PCN # 183
Notification Date:
18 May 2020

Product / Process Change Notice

Chip process CP390, N-channel MOSFETs, wafers and bare die

Figure 1: CP390 Chip Geometry

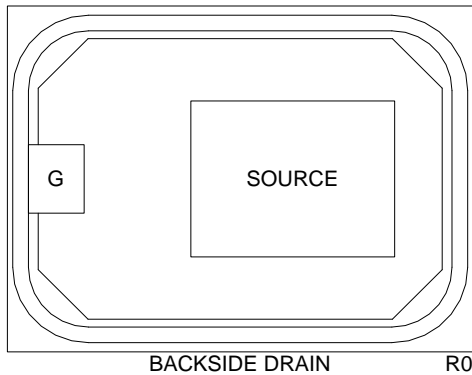
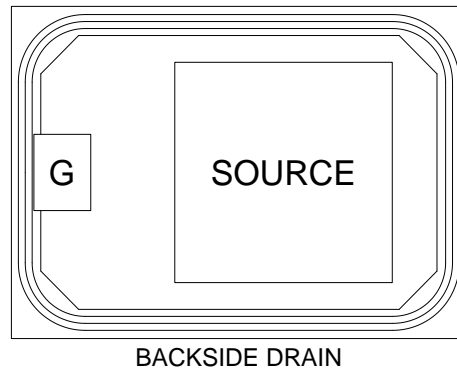
The CP390 wafer process is being replaced by the CP401 wafer process. See Figures 1 and 2 for details.

The CP390 wafer process is being replaced by the CP401 wafer process to enhance the manufacturing process controls and performance. This change will help ensure an undisrupted supply of product. The wafer size has increased from 6 inch to 8 inches in order to improve throughput.

Wafer Diameter: 6 inch
Die Size: 117.0 x 87.4 mils
Die Thickness: 9.1 mils
Bond Pad Size (Gate): 14.0 x 17.3 mils
Bond Pad Size (Source): 51.2 x 39.4 mils
Topside Metal: Al (43,000Å)
Backside Metal: Ag (8,000Å)

Wafer Diameter: 8 inch
Die Size: 107.1 x 77.2 mils
Die Thickness: 9.1 mils
Bond Pad Size (Gate): 13.4 x 17.7 mils
Bond Pad Size (Source): 51.2 x 51.2 mils
Topside Metal: Al-Si (43,000Å)
Backside Metal: Ag (8,000Å)
